Model: 1Bin Tray BN3110		Date: 4-Aug-15	No.: RD692001
Subject: JAM64		Prepared by: E.Hinata	
From: 1st Tech Service Sect., MFP/P Tech Service Dept.			
Classification:	<input checked="" type="checkbox"/> Troubleshooting	<input type="checkbox"/> Part information	<input type="checkbox"/> Action required
	<input type="checkbox"/> Mechanical	<input type="checkbox"/> Electrical	<input type="checkbox"/> Service manual revision
	<input type="checkbox"/> Paper path	<input type="checkbox"/> Transmit/receive	<input type="checkbox"/> Retrofit information
	<input type="checkbox"/> Product Safety	<input type="checkbox"/> Other ()	<input type="checkbox"/> Tier 2

Model: 1Bin Tray BN3110		Date: 25-Nov-15	No.: RD692002
Subject: Cannot remove jammed paper showing JAM code 64		Prepared by: T. Hirakawa	
From: 1st Field Quality Manement sect. FQM Dept.			
Classification:	<input checked="" type="checkbox"/> Troubleshooting <input type="checkbox"/> Mechanical <input type="checkbox"/> Paper path <input type="checkbox"/> Product Safety	<input type="checkbox"/> Part information <input type="checkbox"/> Electrical <input type="checkbox"/> Transmit/receive <input type="checkbox"/> Other ()	<input type="checkb

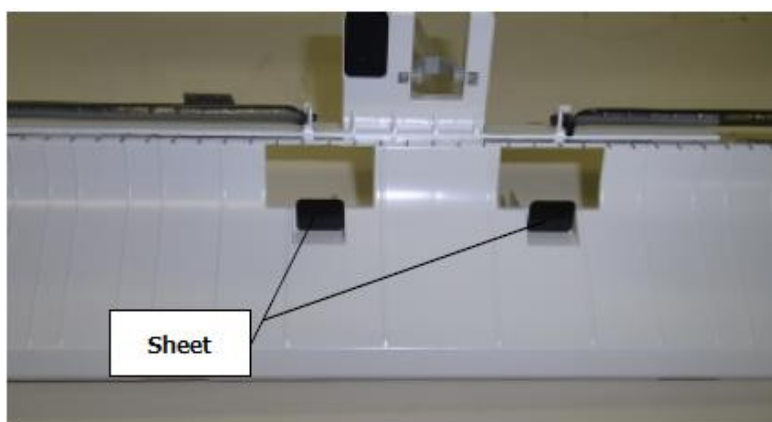
The leading edge of damp and curled paper tends to contact the guide Mylar that was added in front of the exit roller. The paper jams and becomes folded up (an accordion jam). As a result, the operator cannot see the jammed paper and initiates a service call.

6. Remove the two sheets from the upper frame.

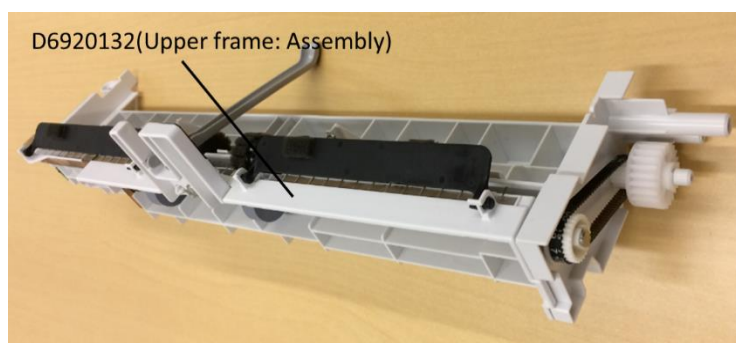
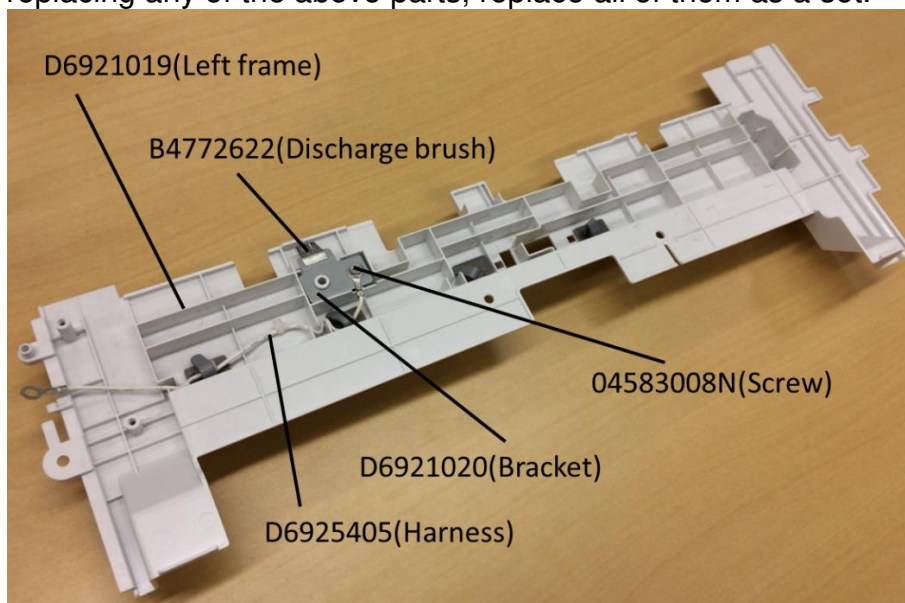
Old part number	New part number	Description	Q'ty	Int	set	Int
D6921016	D6921019	FRAME:LEFT	1	X/X	A	X/O as a set
—	D6921020	BRACKET:GROUND WIRE	1	—	A	
—	D6925405	HARNESS:TERMINAL	1	—	A	
—	04583008N	HEXAGON HEAD TAPPING SCREW:3X8	1	—	A	
—	B4726622	DISCHARGE BRUSH:L11	1	—	A	
D6920130	D6920132	FRAME:UPPER LOWER:ASS'Y	1	X/X	A

To lower the level of static noise generated.

NOTE: When replacing any of the above parts, replace all of them as a set.
